**Committee:** Planning Committee  
**Date:** Thursday 8 September 2022  
**Time:** 4.00 pm  
**Venue** Bodicote House, Bodicote, Banbury, Oxon OX15 4AA

### 8. **Development Brief for Local Plan Partial Review site PR6a – Land East of Oxford Road, North Oxford** (Pages 10 - 170)

Figure 15: Urban design

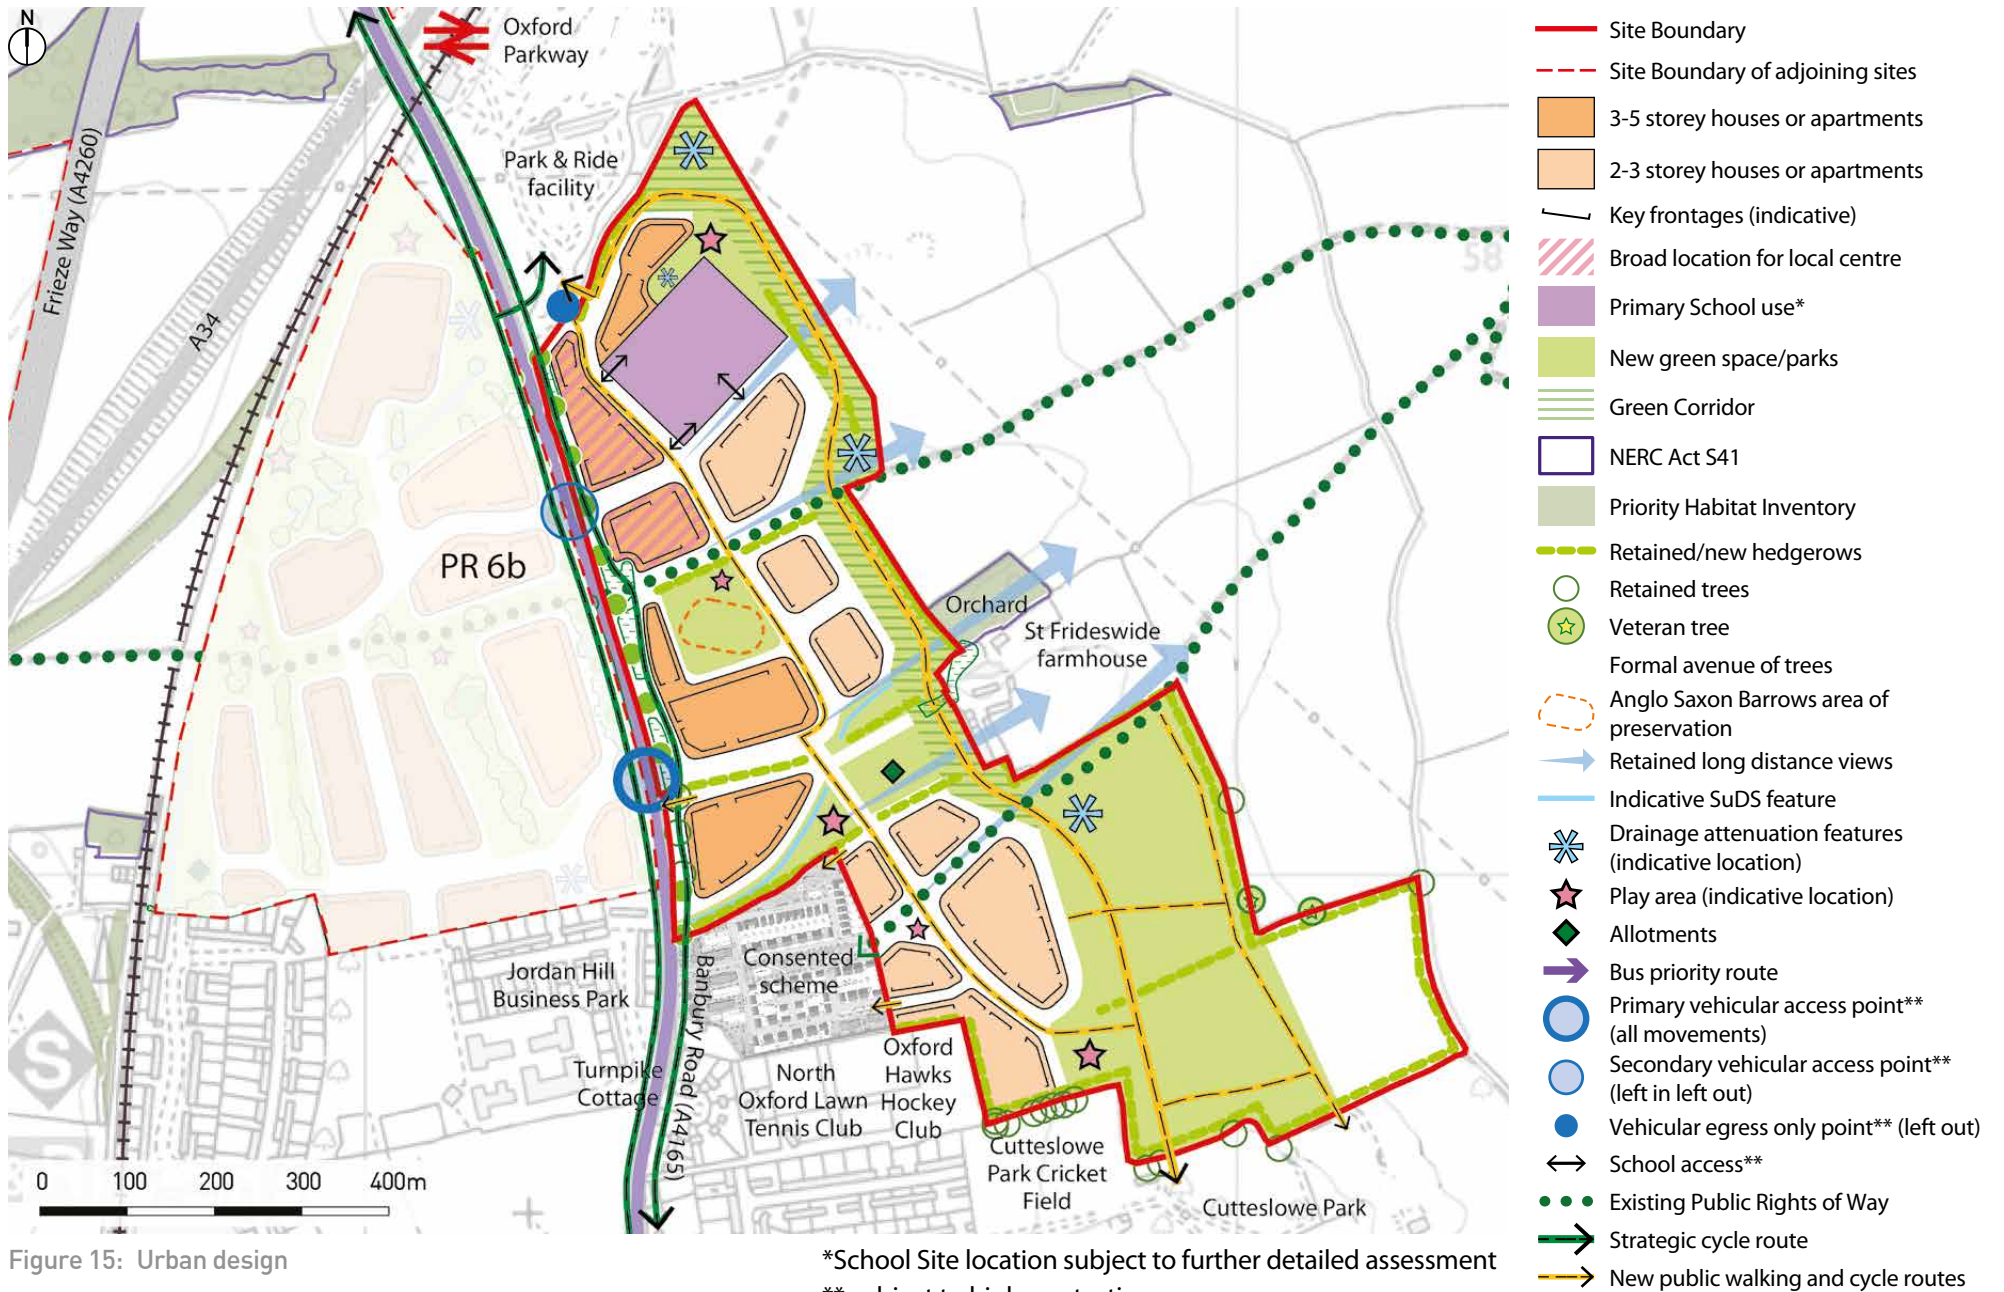
Savills (land promoter)	Fig 15 - The Croudace scheme should be shown in outline on the plan (like the PR6b development blocks).	Noted - the appropriate figures should be updated to reflect this approved layout for the Croudace development	The appropriate figures will be updated to reflect this approved layout for the Croudace development	Changed - as above
Savills (land promoter)	Fig 15 - The area shown below is identified in Figure 1 (Development Framework) as 'residential'. Requests that a development perimeter block is identified in this location. (extract of Figure 15 shown)	This is shown as the location for the allotments. It is also an important long distance view to retain and an important space for the setting of the listed building to the east of the site.	None

- the appropriate figures have been updated to reflect this approved layout for the Croudace development
- text of section 6.5 has been amended, but reference to land outside the allocated boundary has not been included as this is outside the remit of the development brief
- reference to the aggregate rail depot has been added to figure 10 and section 4.1
- section 4.2.5 - the 2nd bullet point has been amended to read: "Opportunity to integrate the site layout with adjacent development sites including PR6b and movement links outside the site including an onwards link to the Oxford North site via high quality crossing of Oxford Road and the rail line, and an onward link over the A40 via the existing bridge adjoining Cutteslowe Park. Regard should be had to published guidance including the Oxford and Kidlington Local Cycling and Walking Infrastructure Plans."

Figure 17: A-A – indicative proposals for improvements to Oxford Road showing relationship to PR6b and PR6b frontages (subject to final Oxford Road design by OCC).

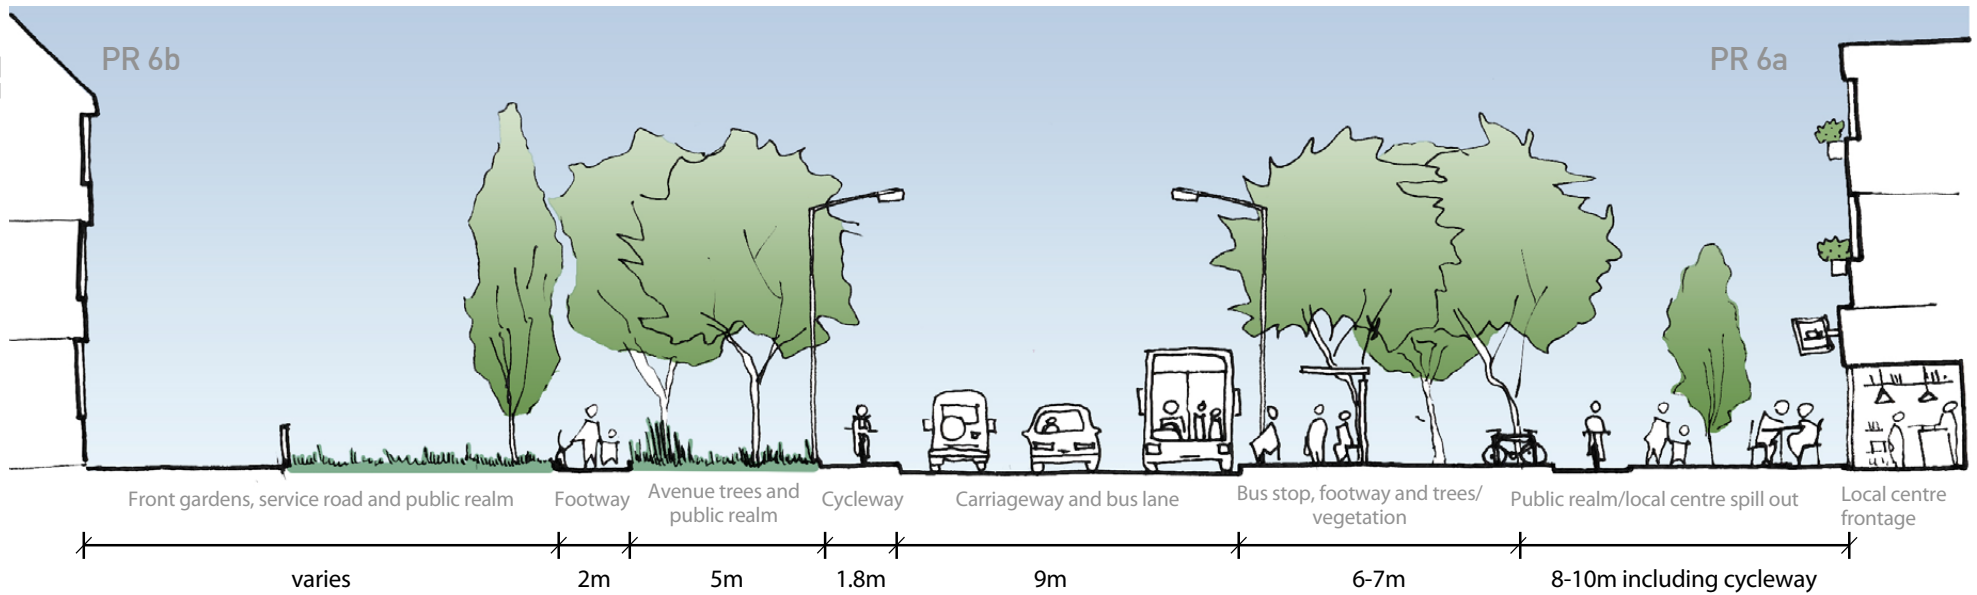
Savills (land promoter)	Figure 17: This figure shows the wholesale removal of vegetation under trees and the cycle way aligned through the existing vegetation and under tree canopy. The orientation of the cycle way through the vegetation in this way does not allow much provision for the retention of the woodland habitat on the Oxford Road frontage. Amend: Change plan to plot the cycle route to avoid existing vegetation, where possible. Figure 17: The 8-10m shown in front of the local centre is an arrangement that could allow shared street vehicular access in addition to pedestrian and cycle access to these frontages and would seem to work well.	We would agree with regard to the location of the cycleways and have discussed this with the land promoter - the development brief will be amended in this regard. The northern location of the school makes use of the cycle and footways through the site in the same way that the central location would.	The figures on page 37 will be amended to show the cycleways further into the site away from the Oxford Road frontage.	Figure 17 section. Cycleway moved to within 8-10m area. Middle tree is put back to the east of Oxford Road that was removed. Tree was put back to the west of Oxford Road.

Savills (land promoter)	Figure 17: The land promoter is not certain that the local centre should 'front' onto Oxford Road. The land promoter envisages that the local centre potentially having visibility from the Oxford Road, but facing into the site to create an area that is suitable for sitting out and conversation between residents. This figure should be amended in relation to the way in which it shows local centre frontage and public realm/local centre spill out.	It is not considered that these should be mutually exclusive - it could do both	None

Savills (land promoter)	Figure 17 is indicative only and as set out is in the title is 'subject to final design by OCC.' The exact alignment will be subject to the outcomes of the traffic modelling and access strategy.	Noted	None	
Savills (land promoter)	Figures 16 and 17: Add text setting out that: Cross sections including the provision of cycle lanes and footways are indicative only, subject to the design of the masterplan. Variations to the cross sections should be allowed, so long as they respond to delivering high quality walking and cycling infrastructure in line with LTN1/20 principles.	The text for Figure 17 notes that it is indicative. Whether variations will be allowed is a matter for the planning application.	None	
Savills (land promoter)	6.3.2 Valley View character area (Page 38) Development Principles, Bullet 4: This principle is unclear. From the western edge of this character area it will not be possible towards St Frideswide Farm and the countryside? Development Principles, Bullet 5: Delete "Parking to the front of properties is to be avoided" as it is not necessary to be specific in this regards.	We would disagree on both counts	None

- The provision of the cycleway will likely require some selective removal of vegetation, and it is recognised the provision of new vehicular accesses will likely also require the same. There isn't the inconsistency suggested by Savills. The first bullet at 6.3.1 also refers to thinning out / removal of some vegetation and refers to retention of the better quality trees. The text at 6.3.1 therefore reflects what is shown in Figure 1 which requires certain groups of trees to be retained "where possible"

Figure 18: B-B – typical primary street cross section  
(refer to Figure 19 for section location)

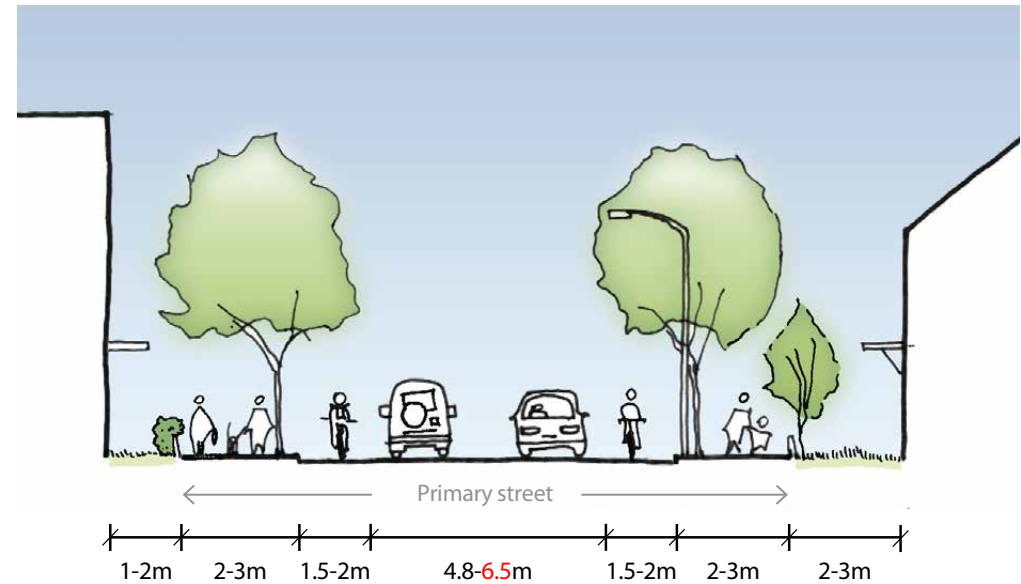
Savills (land promoter)	Development Principles, Bullet 7: The last part of the sentence relating to "which are designed to accommodate large farm vehicles" should be deleted as it is not intended for farm vehicles to use the primary street.	Noted - text to be amended accordingly	See left	Whole sentence deleted, as width of street increased to 6.5m.
Savills (land promoter)	Figure 18: B-B – typical primary street cross section (Page 43) Amend Carriageway width – this should be from 4.8m to 6.5m to allow for future bus access / bus access to the primary school. Add text setting out that: Cross sections including the provision of cycle lanes and footways are indicative only, subject to the design of the masterplan. Variations to the cross sections should be allowed, so long as they respond to delivering high quality walking and cycling infrastructure in line with LTN1/20 principles.	Agreed, with some modifications to what is proposed, recognising the constraints that may exist in parts of the site	Page 43, Figure 18 - Add text on page 43 to state: "Cross sections including the provision of cycle lanes and footways are indicative only and subject to detailed modelling. Variations to the cross sections may be permissible where they respond to delivering high quality walking and cycling infrastructure in line with LTN1/20 principles, or where site constraints may dictate, for example in the central part of the site.	Text added to 6.4.4 intro. Figure 18 label amended.

- page 43, 4th bullet under Development principles - amend 5.5m to 6.5m; 7th bullet - amend 'designend' to "designed"
- page 43, Figure 18 - Add text on page 43 to state: "Cross sections including the provision of cycle lanes and footways are indicative only and subject to detailed modelling. Variations to the cross sections may be permissible where they respond to delivering high quality walking and cycling infrastructure in line with LTN1/20 principles, or where site constraints may dictate, for example in the central part of the site.

Figure 19: Movement and access

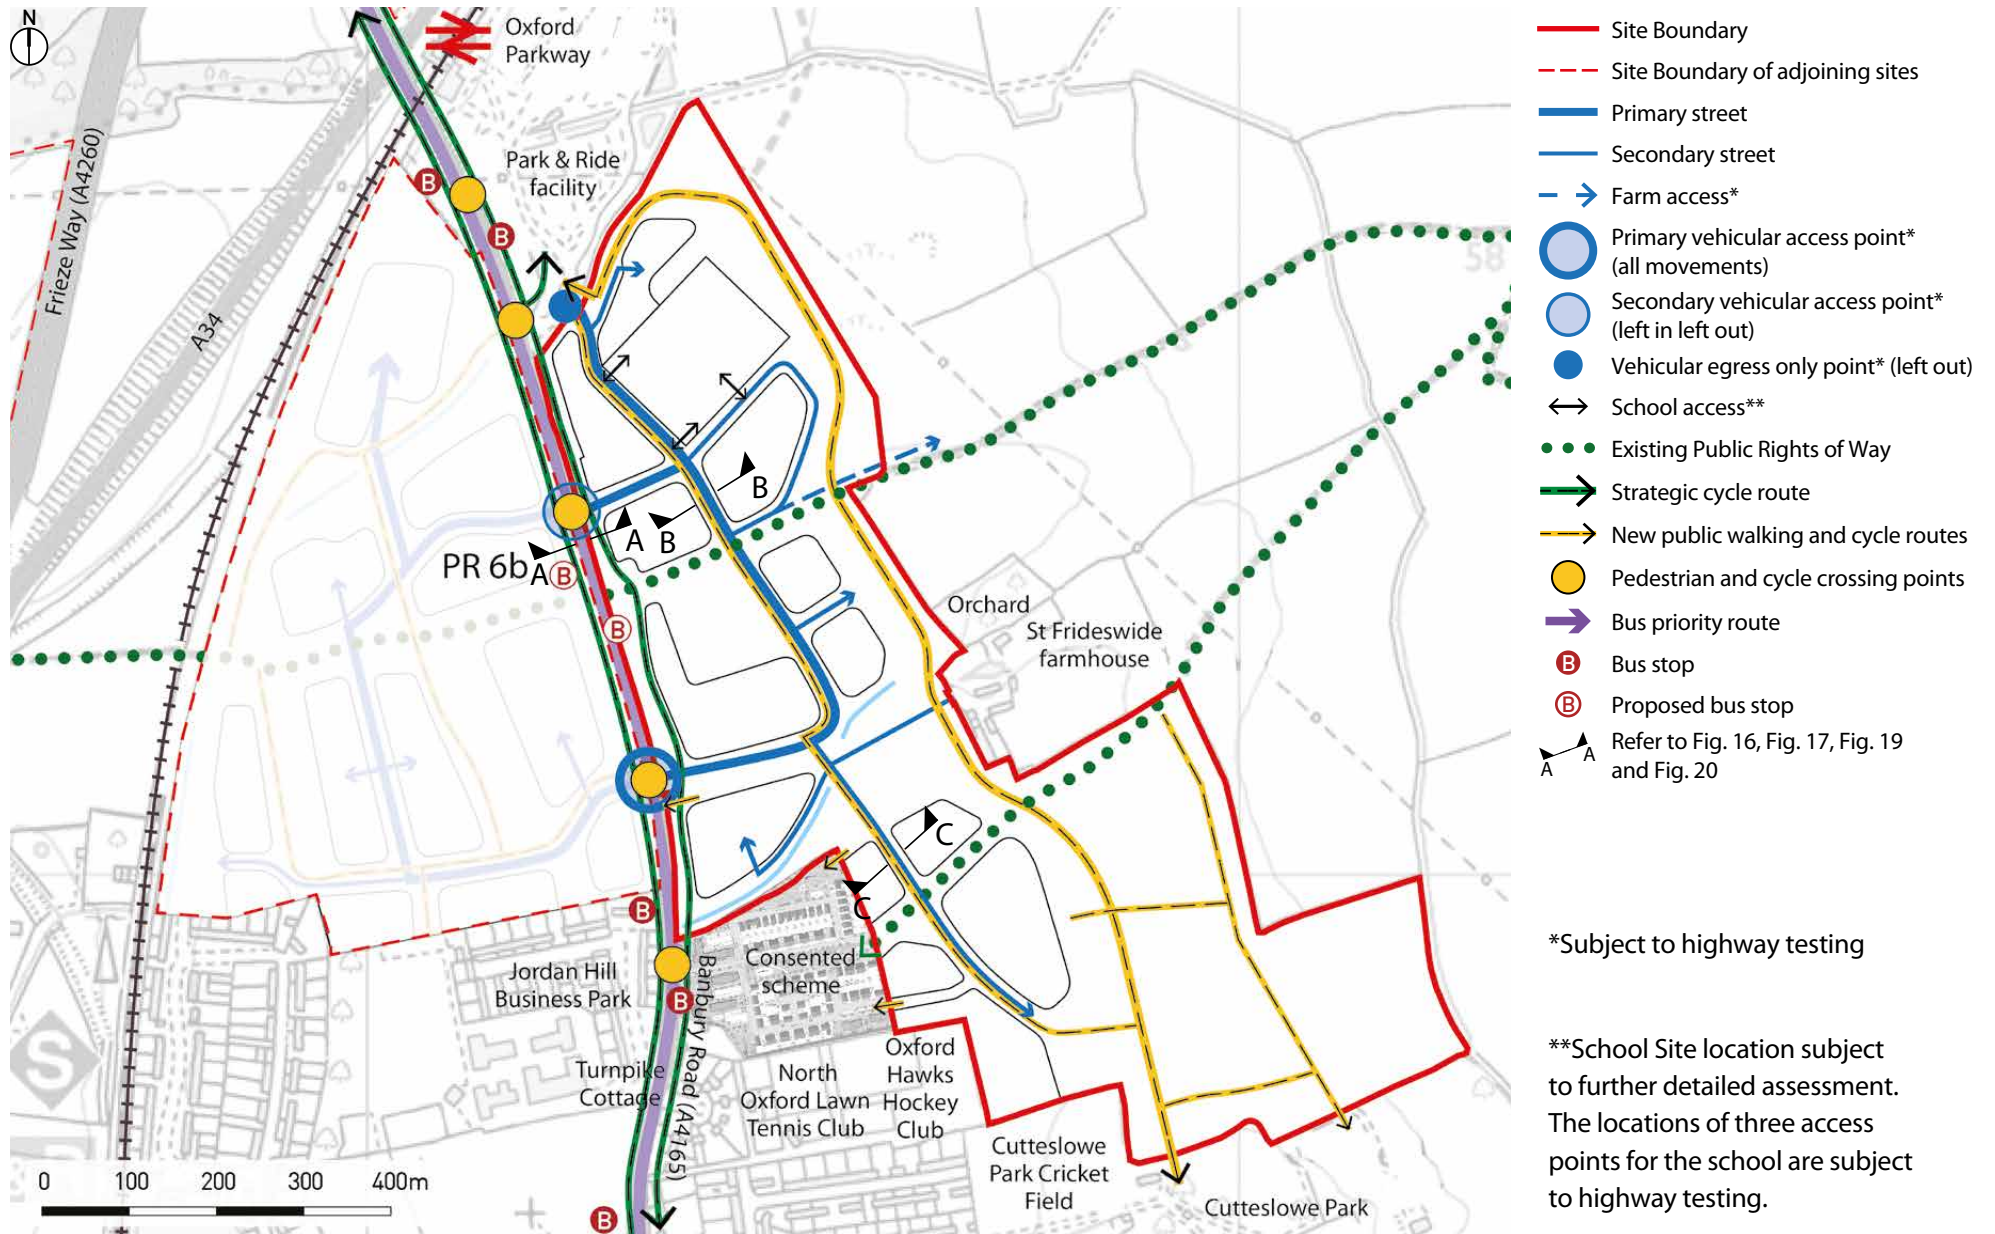
Savills (land promoter)	<p>Amend figure 19 in line with comments below:</p> <ol style="list-style-type: none"> <li>1. The number, location and type of crossing points shown is too prescriptive and does not allow for flexibility in the design of the corridor as a whole. Defining these now could prejudice a better overall design solution.</li> <li>2. Primary Street: This could be extended further south.</li> <li>3. Pedestrian and cycle crossing point adjacent to P&amp;R access to be amended to be 'potential Pedestrian and cycle crossing point*' (subject to detail design and modelling).</li> <li>4. Pedestrian and cycle crossing point opposite secondary access to be relocated to be closer to east west PRow routes. * (subject to detail design and modelling).</li> <li>5. Secondary access: Type of junction should not be identified as 'left in left out' can be left with the ** stating 'Type of junction subject to Traffic Modelling'.</li> <li>6. Vehicular egress point only - not necessary to dictate that the access should be left out only – May be necessary for agricultural access. Amend to state 'Ancillary access point**.'</li> <li>7. Proposed Bus Stops: Add location subject to detail design.</li> </ol>	(1), (3), (5) and (6) - We disagree. (2) We have reviewed this but do not consider it necessary. It will be for the applicant to justify a greater width here. (4) Noted.	None

OCC	<p>Bus Routes</p> <p>There are good existing bus services along the A4165 outside the site, and an existing southbound bus lane. Figure 19 shows a possible location of an additional bus stop near the centre of the site, which we support, subject to detailed assessment.</p>	<p>Noted</p>	None
